Lord Fairfax Health District

RE: Request for Evaluation of Existing System Prior to Issuance of a Bldg Permit
Tax Map: 31C-42; Health Dept. i.d. #: 187120043
owner: Miguel Cortes
page 1 of 2

Health Dept. i.d. # 187120043; County Request for Walkover

Septic Tank - Soil Absorption System Repair Permit

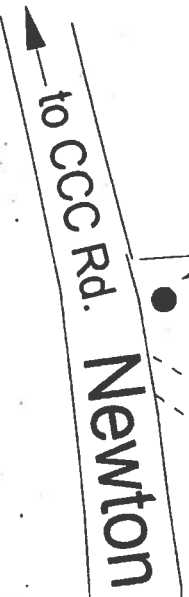
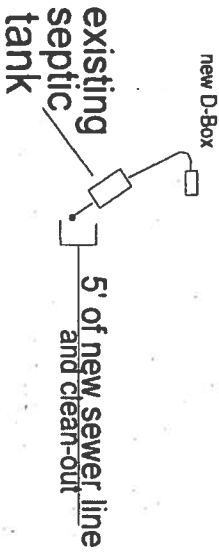
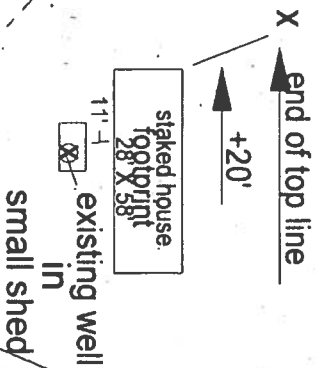
utility pole:
Allegheny Power
L43781
to septic tank = 49'

end of top line to:
utility pole = 142'
cleanout 5' from ST = 95'

D-Box to:
utility pole = 65'
cleanout 5' from ST = 38'

Construction Drawing

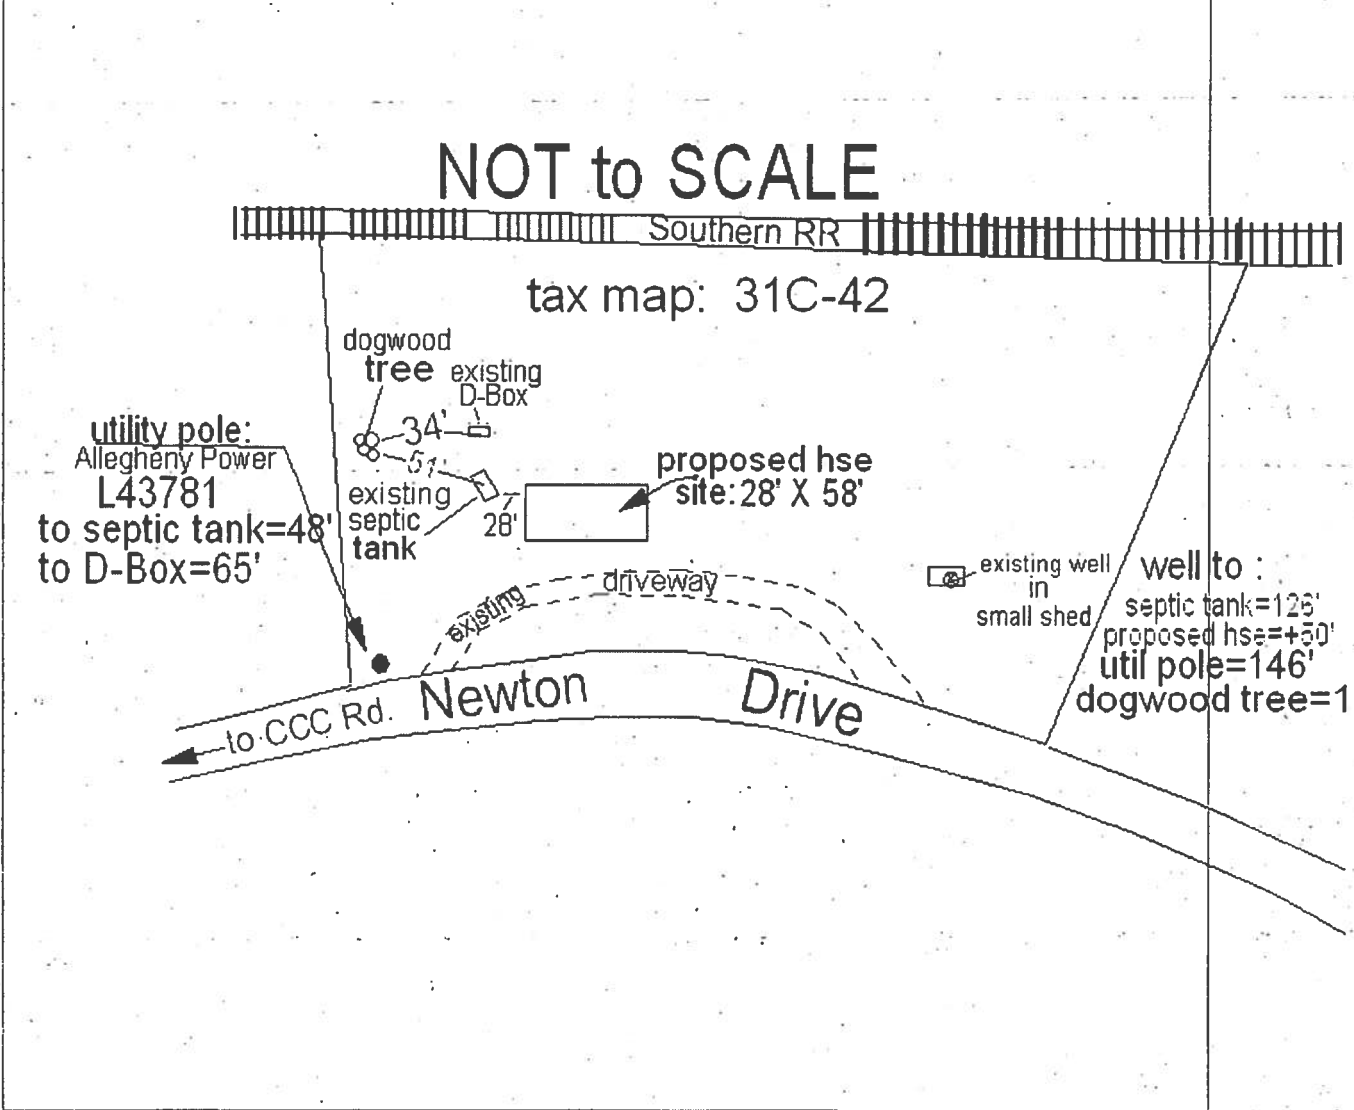
* Needs to
3/13

Fall on tees: 1 1/4"
Extensions: need 18-20' below outlet; depth fr. bottom of tees to bottom of outlet riser = 51-52'
3/10 need 7-10' below inlet; new ~12"
top line = ~98' +/- fr. 2' fr. Dbox
